This Service Information bulletin supersedes SI 18 05 12 dated July 2012.

Voluntary Emissions Recall Campaign 11E-A03: Check and/or Replace Emissions Monitoring Components

E70 and E90 with the M57Y engine produced from April 2009 to September 2010

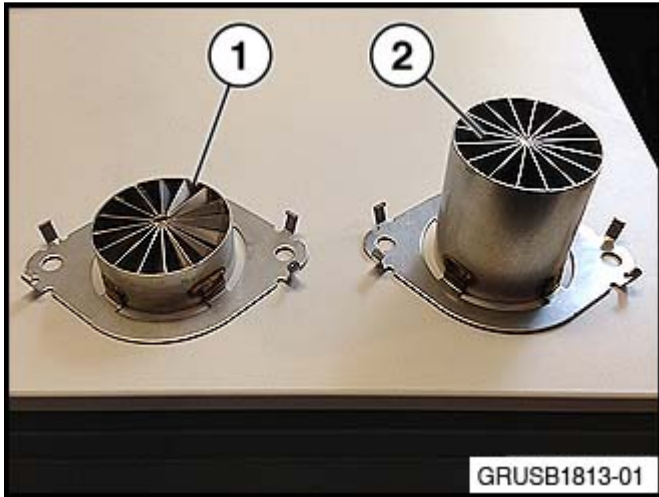
|  | <p>The original style mixer has a multiple fin arrangement (1). This mixer will need to be replaced with P/N 18 30 8 513 445 (E70) or P/N 18 30 8 512 438 (E90).</p> |
|  | <p>If the updated mixer has already been installed, it will have one set of fins (2). No replacement is necessary. Reinstall the SCR front pipe to the down pipe of the DPF.</p> |

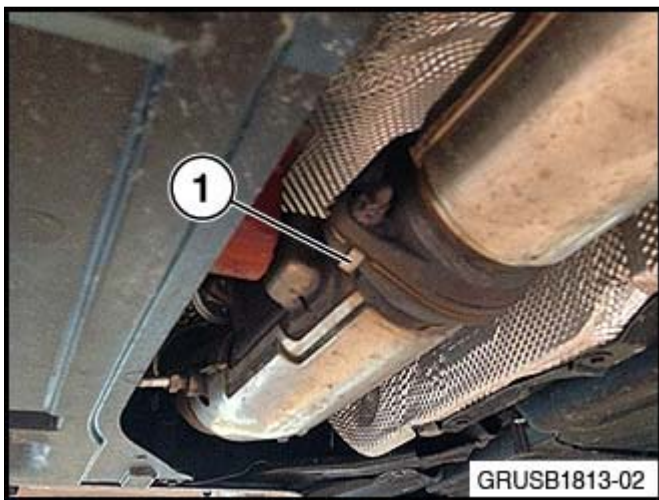
NEW 1. The E90 mixer (1) is shorter than the E70 mixer (2).

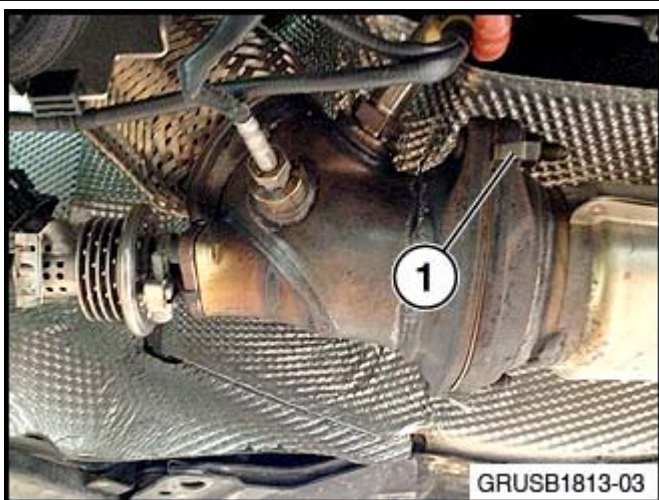
NEW 1. The barrel of the E70 mixer points toward the front of the car. This is easily identified by the mixer tabs wrapped around the front pipe flange (1).

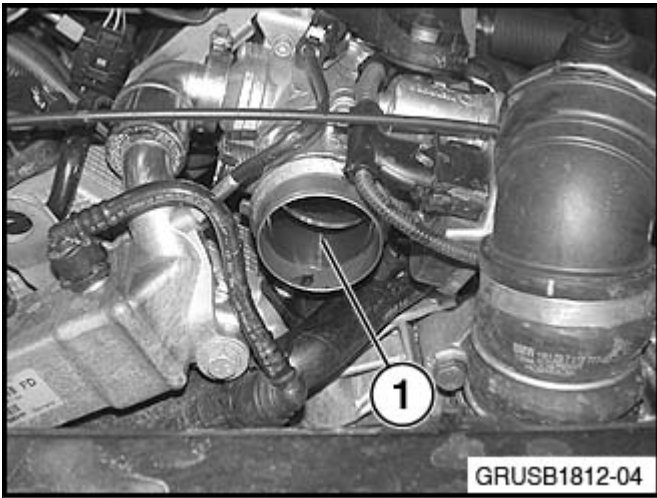
NEW 1. The barrel of the E90 mixer points toward the rear of the car. This is identified by the mixer tabs wrapped around the flange on the SCR cat (1).

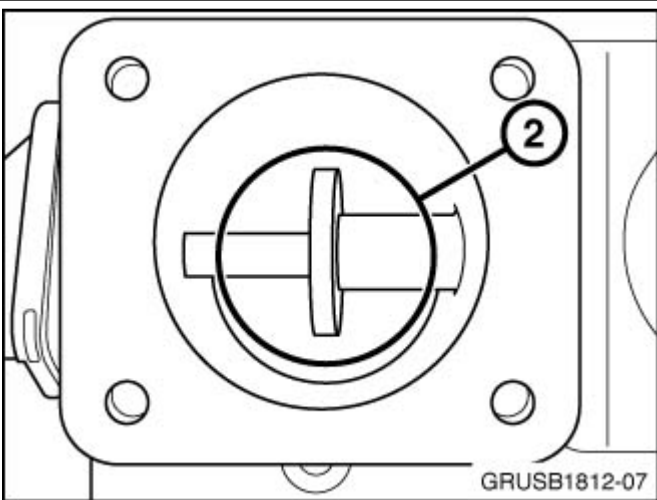
The updated EGR valve (P/N 11 71 8 517 217 or P/N 11 71 8 512 526) has the valve and seat directly in the airstream of the throttle (1). If this valve is installed, no further action is needed. Reinstall the charge air pipe.

The original EGR valve has a diffuser in the airstream flow from the throttle (2). The valve for EGR actuation is seated further into the EGR airstream. Replace this valve with P/N 11 71 8 512 526 (Repair Instruction 11 71 501).
